# Device Errata

## NL-M1DK

Published // August 2017

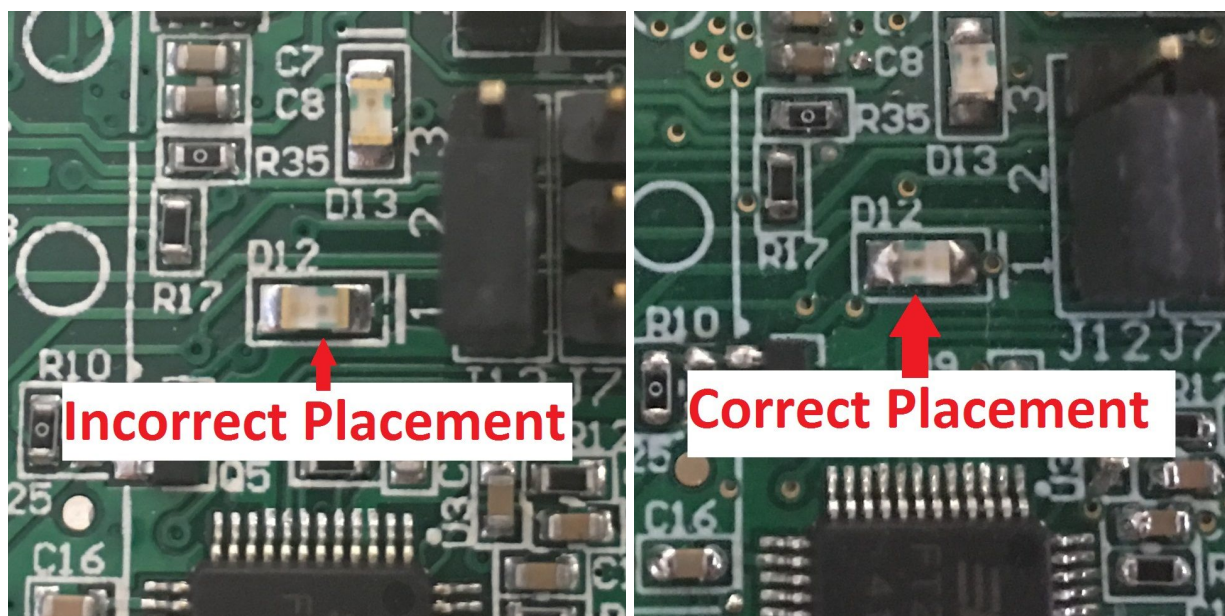
The manufacturer date code is located on the back side of the PCB assembly on a white sticker. The serial number is the nine digit number after "BTW" on the sticker. This Errata affects all NL-M1DK PCB assemblies with serial numbers 308940000 through 308940250.
